Access Compliance Report

Public Rights-of-Way

Intersection ID: 30595	Main Street: LAMINGTON_RD	Cross Street: STONEMEDE_LN	Location: NW
ADA ID: 3E63FCE32F93	Ramp Type: PerpDiag	Initial Pass/Fail: Fail	Overall Compliance: No
		Severity Score: 10

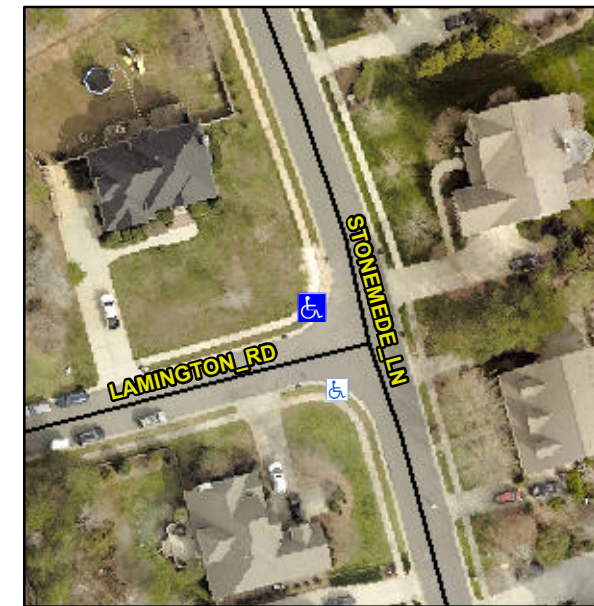
Not Found, R304.5.1, R304.5.3

Compliance	Description	Data	Compliance	Description	Data
N/A	Ramp Length (in)	49.5	Yes	Ramp Slope (%)	5.0
No	Ramp Width (in)	44.5	No	Ramp XSlope (%)	4.4
N/A	Flare Type LT	N/A	N/A	Flare Type RT	N/A
N/A	Flare Slope LT (%)	N/A	N/A	Flare Slope RT (%)	N/A
N/A	Flare Traversable LT?	N/A	N/A	Flare Traversable RT?	N/A
N/A	Landing Length (in)	N/A	N/A	DWS Provided?	N/A
N/A	Landing Width (in)	N/A	N/A	DWS Contrast?	N/A
N/A	Landing Slope (%)	N/A	N/A	DWS Length (in)	N/A
N/A	Landing X Slope (%)	N/A	N/A	DWS Full Width?	N/A
N/A	Landing Curb? (Y/N)	N/A	N/A	DWS Offset (in)	N/A
N/A	Shared Landing?	N/A			
N/A	Gutter Ponding?	N/A	N/A	Gutter Slope (%)	N/A
N/A	Gutter Lip Ht (in)	N/A	N/A	Gutter X Slope (%)	N/A
N/A	Painted X Walk1?	No	N/A	Painted X Walk2?	No
	X Walk 1 Direction	To S		X Walk 2 Direction	To E
N/A	X Walk 1 Width (in)	N/A	N/A	X Walk 2 Width (in)	N/A
	X Walk 1 Slope (%)	0.2		X Walk 2 Slope (%)	2.6
	X Walk 1 X Slope (%)	4.8		X Walk 2 X Slope (%)	1.5

Remove & Replace Curb Ramp With Two New Directional Ramps or Equivalent.
